## MINUTES

### MEETING BETWEEN COUNCIL AND AQUALAND 19/05/22

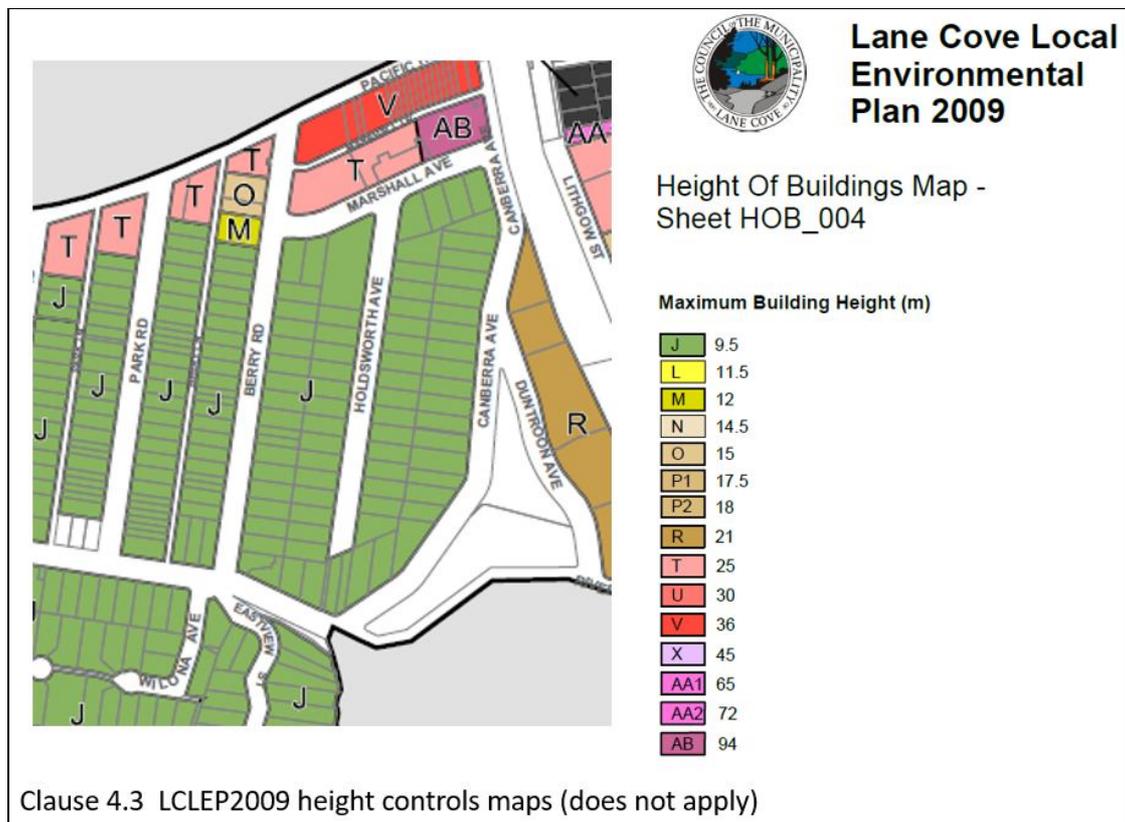
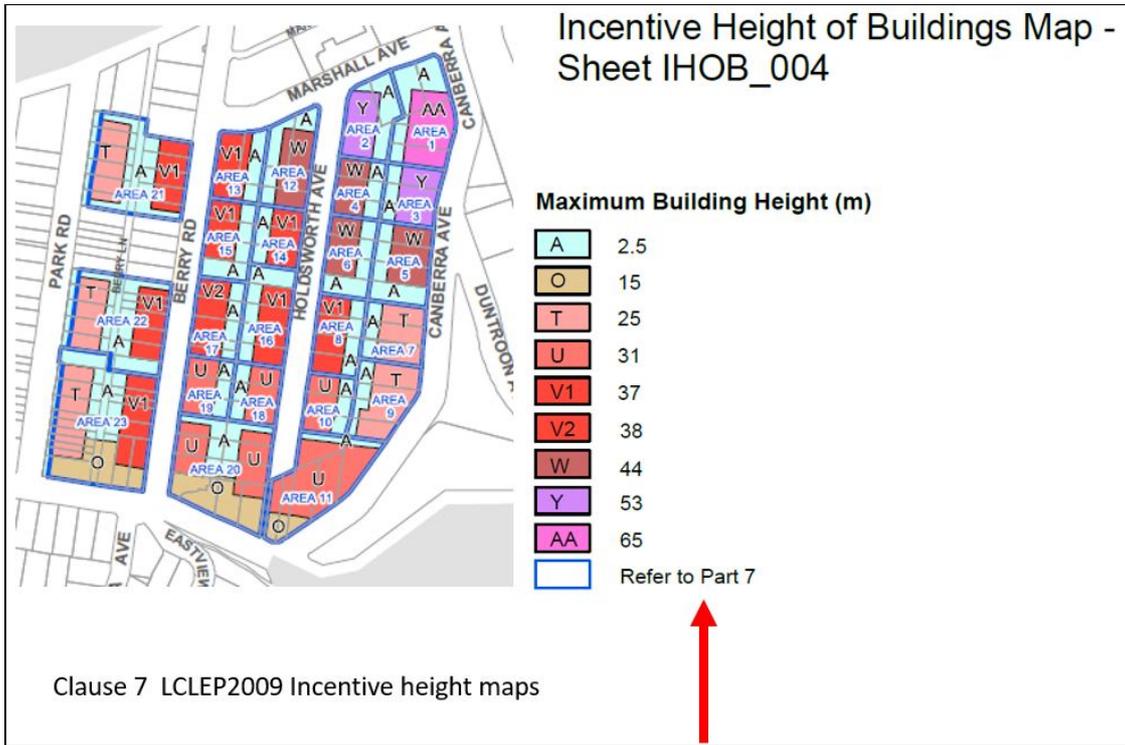
The rooftop articulation elements breach the LEP height envelope controls by up to 14%. The documentation incorrectly references Clause 5.6 of the Lane Cove LEP 2009 (LCLEP2009) to permit this variation as an architectural roof feature. **Clause 5.6 does not apply** to the St Leonards South precinct. St Leonards South height and FSR is governed under Clause 7 in the LCLEP2009.

Clause 5.6 (2) relates to the old building height maps under clause 4.3 which limit the height controls as 9.5m. No mention /reference to Clause 7 St Leonards South incentive heights is included in Clause 5.6 (2)

St Leonards South has its own specific incentive height and FSR controls in Part 7 of the LCLEP 2009 which permit the incentive height increases above the previous 9.5m height controls.

Council cannot support any variation or breach of the controls of Area 16 (37m) and Area 17 (38m) under Clause 7.

Section demonstrating height in storeys

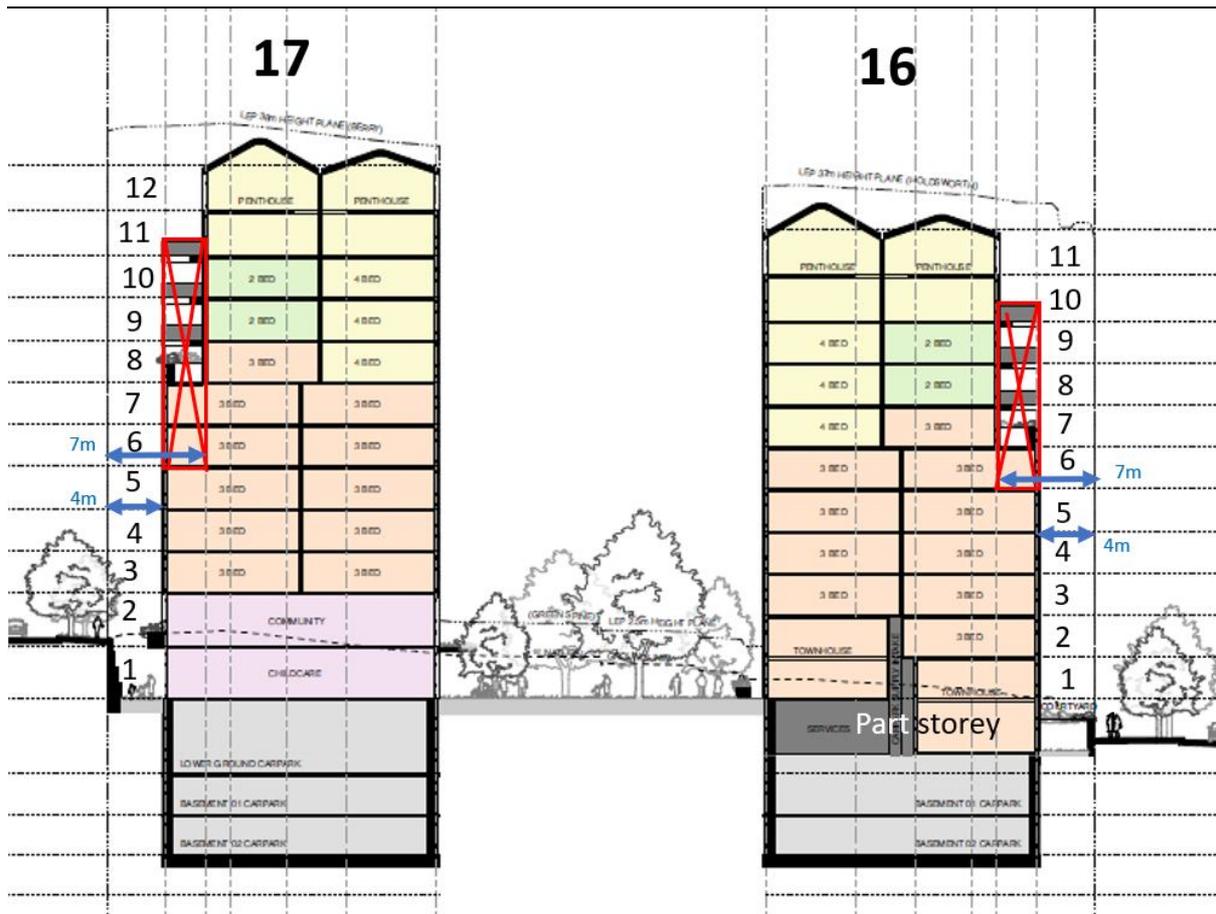
**Area 16:** The storey which results from excavation on a steep slope and partially accommodates associated basement parking uses (services) is eligible to be classified as a part storey. Notwithstanding the above the proposed sectional drawings demonstrate a 11-storey building. This does not comply with the 10-storey height control in the DCP.

**Area 17:** The new sectional drawings demonstrate a 12-storey building. The excavated level to accommodate the childcare centre is classified as a full storey. This does not comply with the 10-storey height control of the Lane Cove DCP.
